Update to BZA Application 19164

This document contains an update:

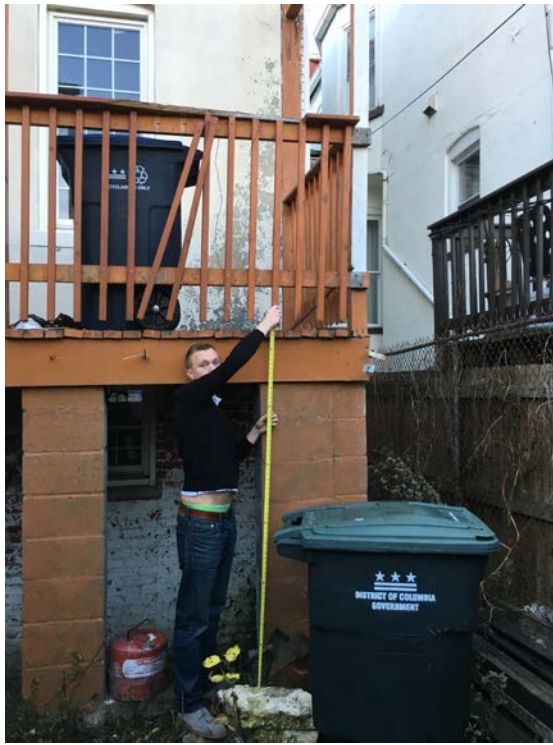
- **Planning Comment #1:** First question – a 4th story is not allowed in the R-4 unless you have more than 6'6" existing internal space. Do you have that internal height now? If there isn't that height you cannot expand that floor.

- **Response to Planning Comment #1:** Please see below for more full description of height and stories, which confirms the height of the top level is over 7'. In terms of DCRA's position, they have made clear that it is considered four stories (see screenshot below from DCRA in September) and that is why a zoning variance is required. NOTE: Some confusion may be caused by the important distinction that only three stories are above grade plane.

- o **Height/Stories:** Calculation of the official height of the home has changed slightly from the original submission, in consultation with DCRA and the Office of Planning, to address grade plane. The existing structure has 3 stories above grade plane, plus a basement. This is a total of 4 existing stories. The proposed structure also has 3 stories above grade plane, plus a basement. This is an unchanged total of 4 proposed stories. Both existing and proposed structures maintain the same overall height.
 - Grade Plane Calculation (5'6.5") – Existing and Proposed
 - o Front measure of distance from ground level to the floor of the finished first floor (4'9") (picture below)

- o Rear measure of distance from ground level to the floor of the finished first floor (6'4")

- o Average of front and rear measure/grade plane is therefore 5'6.5"
- o Since the grade plane is less than 6', basement is not a story above grade plane
- Height Calculation from Grade Plane for Existing Home (37'2.5")
 - o Grade plane to finished first floor above grade plane (5'6.5")
 - o Finished first floor to finished second floor above grade plane (10'8")
 - o Finished second floor to finished third floor above grade plane (9'8")
 - o Finished third floor above grade plane to roof (9')
 - o Roof to peak of gable (2'4")
- Height Calculation from Grade Plane for Proposed Home (37'2.5")
 - o Grade plane to finished first floor above grade plane (5'6.5")
 - o Finished first floor to finished second floor above grade plane (10'8")
 - o Finished second floor to finished third floor above grade plane (9'8")
 - o Finished third floor above grade plane to peak of gable (11'4")

Images: Existing Front of Home and Overlay of Proposed Alteration

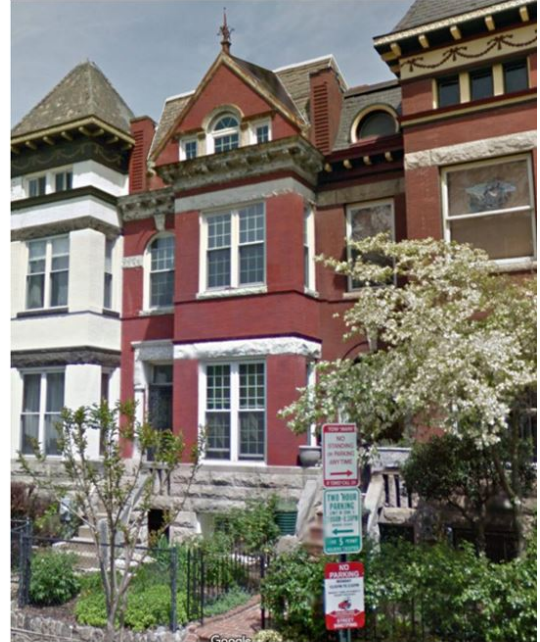
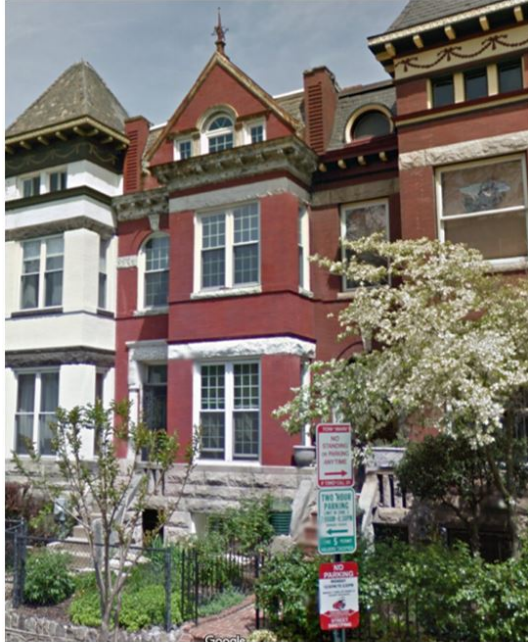
- **Planning Comment #8:** The R-4 regulations include the following language and the BZA has been closely evaluating proposed changes to roof forms.

- o **Response to Planning Comment #8:** In conducting outreach to the community, during the zoning variance process, the following overlays have been generated to demonstrate the proposed alterations and the commitment to maintaining the architectural character of the home, true to the intent of recent changes to regulations.

- No substantial changes to the architecture on the street side
- Similar materials as the original materials used to maintain the character on the street side
- All proposed additions and alterations are made within the same footprint as existing structure
